**In the Drawings**

### **REMARKS**

FIG. 1

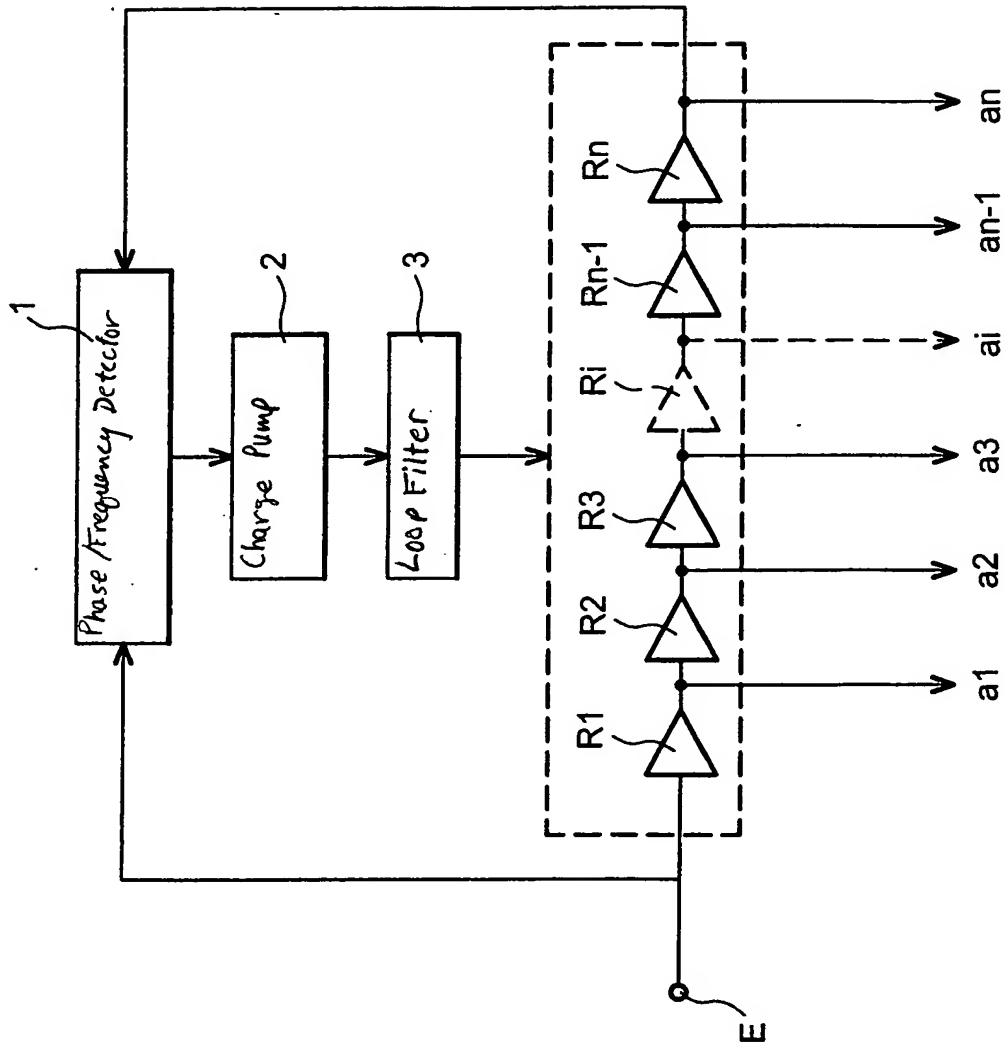
The attached replacement and annotated sheet(s) of drawings include changes to FIGS. 1-4, 5A and 5B. Specifically, FIGS. 1-4, 5A and 5B have been amended to provide descriptive legends to the boxes therein. Further, FIGS. 4 and 5B have been amended to add labels Ip1 – Ipn and Iq1 – Iqn consistent with the specification.

The drawing figures have been corrected in accordance with the Examiner's suggestions. Specifically, FIGS. 1-4, 5A and 5B have been amended to provide descriptive legends to the boxes therein. Further, FIGS. 4 and 5B have been amended to add labels Ip1 – Ipn and Iq1 – Iqn consistent with the specification. No new matter has been introduced. Approval of the corrections is respectfully requested.
